**DRAFT CONDITIONS OF APPROVAL**  
**P18-0081: UP19-0008, DR19-0028, TDM19-0004, WM19-0002, PMMP19-0001, SA19-0001,**  
**1051 MISSION ROAD**

*(As recommended by City Staff on November 13, 2019)*

Figure A - Building B – All Floors

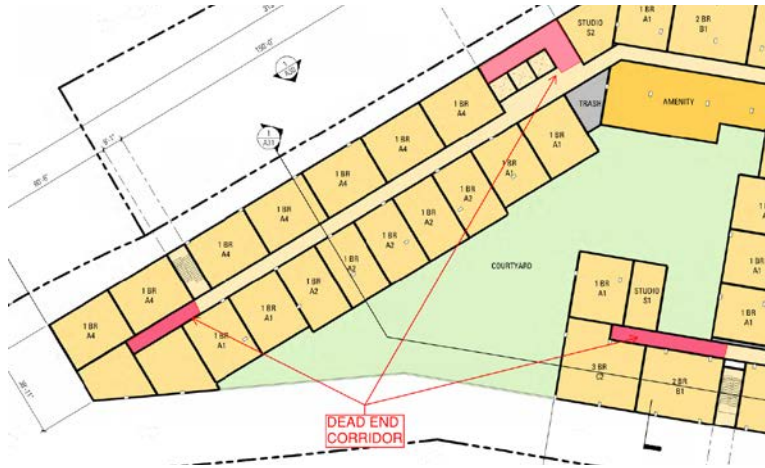
- All Buildings:
  - Ensure dead end corridors do not exceed 50 feet. CBC 1020.4. See figures below for example.
